TB 138A

TECHNICAL BULLETIN

Product : Midilift

Subject : Shims added to fire door mounting arrangement (Revision A).

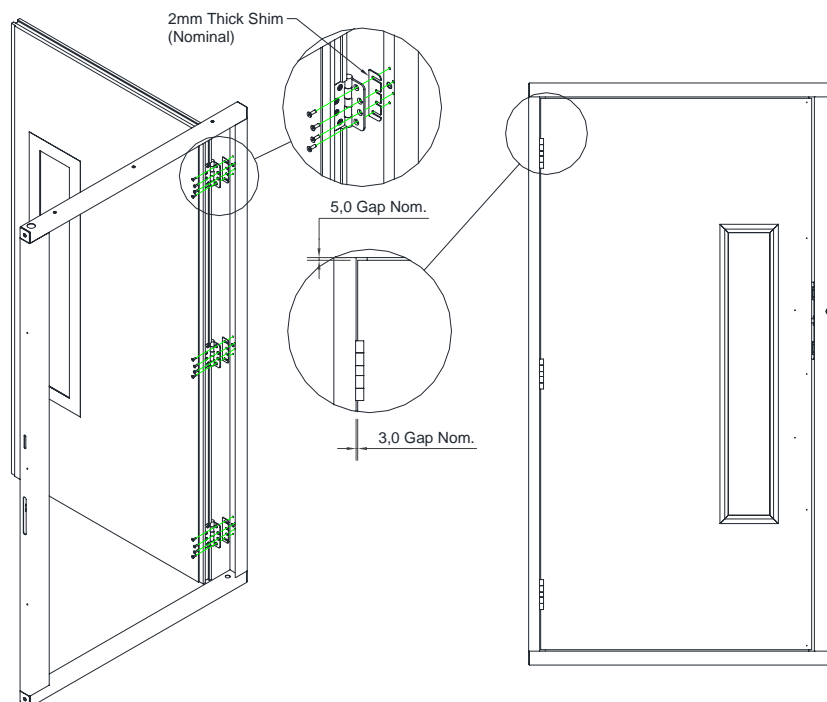
When mounting a fire door, a shim is now required between the hinge and the metal door frame. The shim has been introduced to ensure the fixing doesn't bottom out on the frame before properly securing the hinge to the frame and is a result of changes to the hinge.

Two thicknesses of shim will be included in the kit box. The 2mm should be used for mounting the fire door as shown, however a 1.2mm shim is included to allow slight adjustment when required. A nominal 3mm gap should be maintained on the hinge side as shown with a 5mm gap at the top and bottom of the door.

A number of lifts manufactured following this date will still employ the 'old' hinge. In these instances, shims should not be fitted between the hinge and the frame as this could result in binding on the leading edge of the door.

New Hinge - Shims required	Old Hinge - Shims <u>not</u> required

<p> Brand: Eclipse Plate Thickness: 3mm Pin Diameter: 14mm </p>	<p> Brand: Phoenix Plate Thickness: 2.5mm Pin Diameter: 12mm </p>
